Technical Service Information

THM 440-T4 WELDED 4TH CLUTCH

Figure 1
AUTOMATIC TRANSMISSION SERVICE GROUP

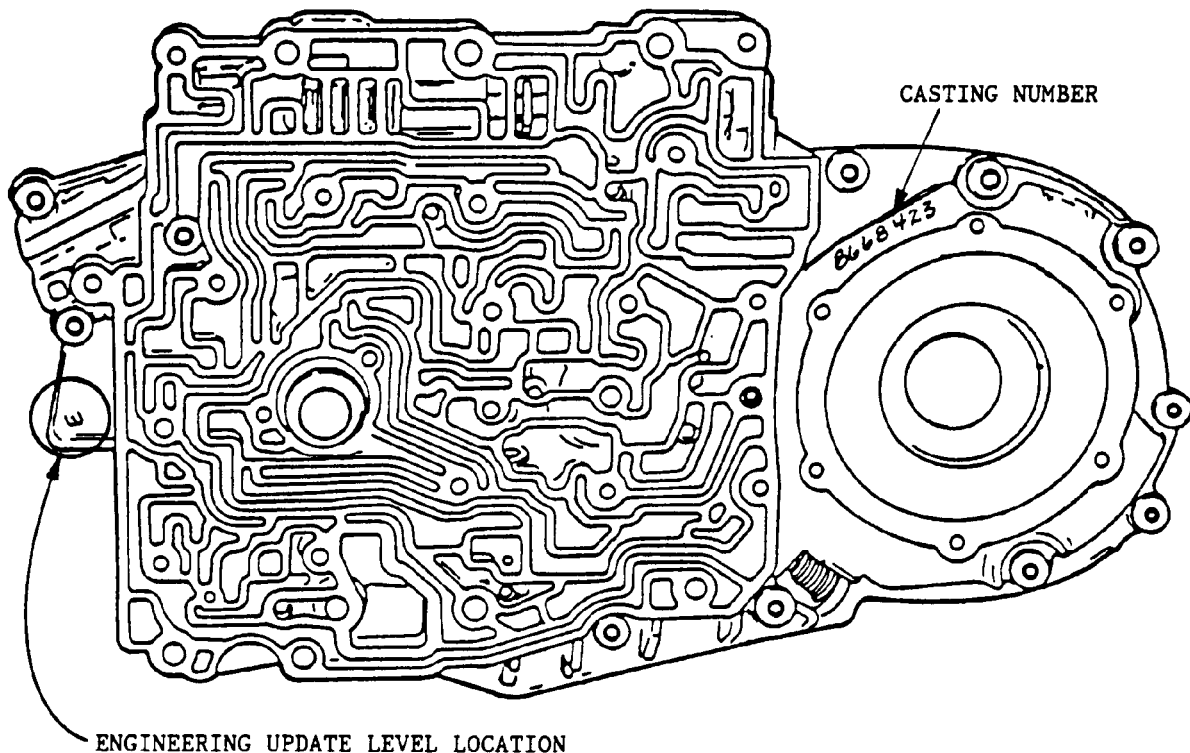
CAUSE The cause may be the manual valve being positioned between the neutral and D4 position, which would allow the input clutch to be applied in 4th gear. This was created by a change in the channel plate porting, in the manual valve area. The questionable channel plate can be identified by the casting number "8668423", with engineering update level "E". Refer to Figure 1 for locations. Casting number "8668423" with engineering update levels "A", "B", "C", and "D" are OK to use. **DO NOT USE CASTING NO. "8668423" WITH ENGINEERING UPDATE LEVEL OF "E" OR HIGHER - REFER TO FIGURE 1 FOR LOCATIONS.**

CORRECTION: Install an earlier model channel plate that does not have the questionable casting number 8668423. There is also a new service package available from OEM, to address this condition. The new service package contains the following:

Figure 2

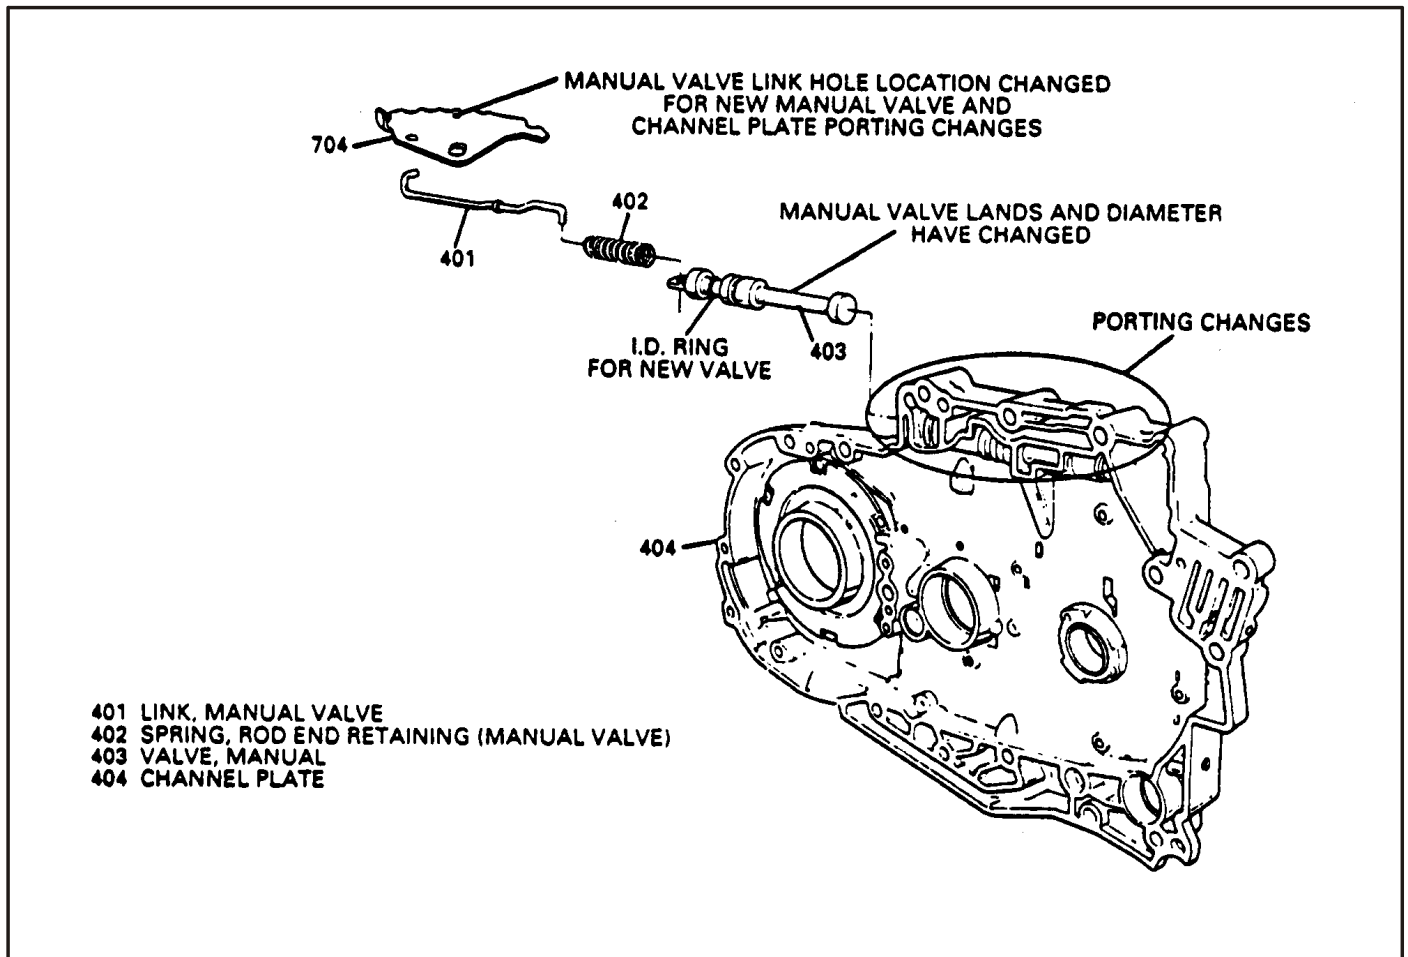
NEW CHANNEL PLATE - Will have porting changes for the new manual valve and new inside detent lever. The porting changes will help ensure that two ports will never be opened at once to cause burnt 4th clutch assembly. The bore for the new manual valve will be reduced by .010" to accommodate the new manual valve. This will make the previous and new parts non-interchangeable. (See Figure 2).

Figure 3

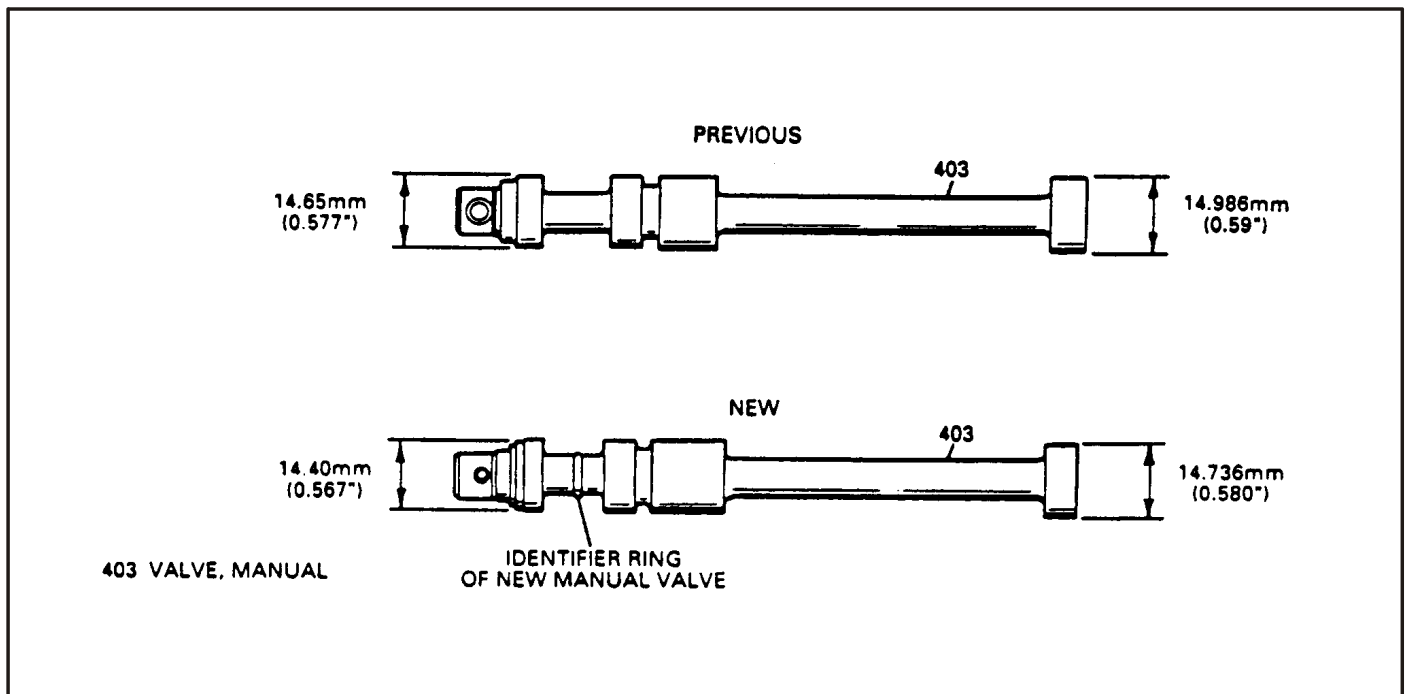
NEW MANUAL VALVE - Will have changes to the valve lands and reduced .010" in diameter for the new porting changes in the channel plate. The previous and new manual valves are not interchangeable. The new manual valve can be identified by a ring between the first two lands as shown in Figure 3.

Figure 4

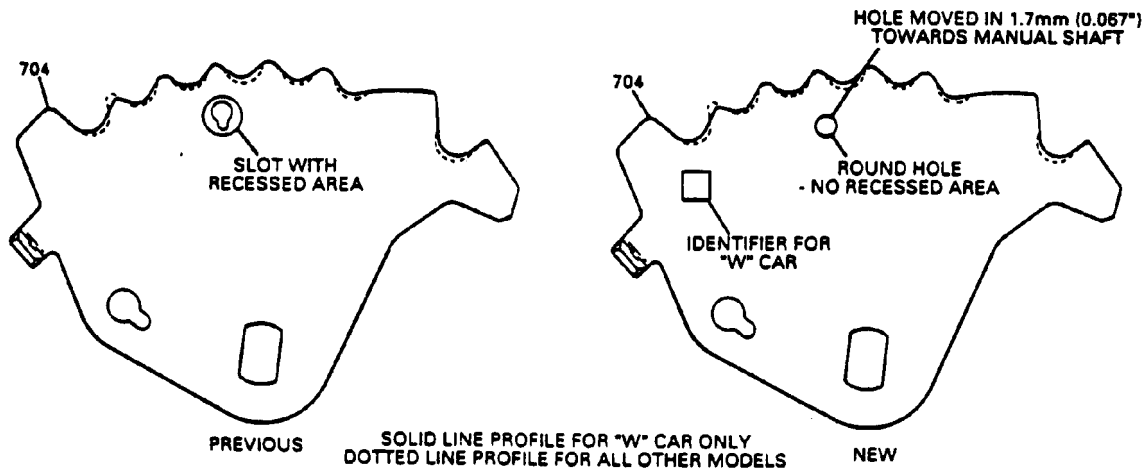
NEW INSIDE DETENT LEVER - Will have the manual link hole location changed to provide a different "Throw" of the manual valve, and the hole is now round instead of "Key Hole" shaped. Since the "W" car detent lever is different than all others, it will have a square identification hole punched in it. The previous and new inside detent levers will not interchange. See Figure 4 for identification.
